ADDENDUM NO. 2

RE: IU BL 000B Multi-Building FY '26 Hardscape Repairs

PROJECT IU: #20250524
No.: ARCH: 25-58

ISSUED BY: Springpoint Architects, p.c.
522 W 2nd Street
Bloomington, Indiana 47403

**SIMON MUSIC CENTER (BL 181);
DEMOLITION PLAN**

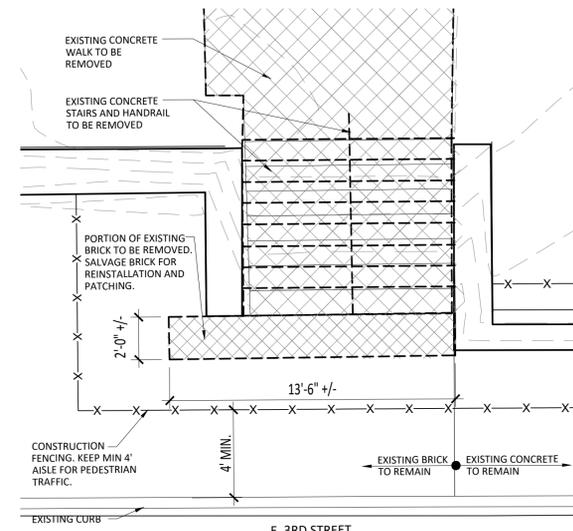
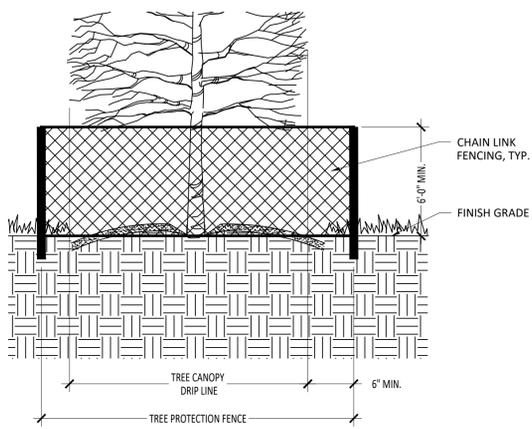
1. General: Showing and noting additional IU utilities throughout including electrical and storm ducts. Contractor shall verify depths of utility ducts in field and report findings to owner/architect.
2. Sheet L101 Simon Music Center
 - a. Tree protection fencing is more defined.

4. TREE PROTECTION FENCING. REF DETAIL D THIS SHEET. EXISTING TREES TO REMAIN AND BE PROTECTED, TYP. CONSTRUCTION TRAFFIC, STAGING, AND STORAGE OF MATERIAL AND EQUIPMENT UNDER DRIPLINE OF ANY TREE SHALL BE PROHIBITED. EXISTING TREES OUTSIDE OF CONSTRUCTION LIMITS SHALL ALSO REMAIN AND BE PROTECTED FROM ALL CONSTRUCTION ACTIVITY, TYP.
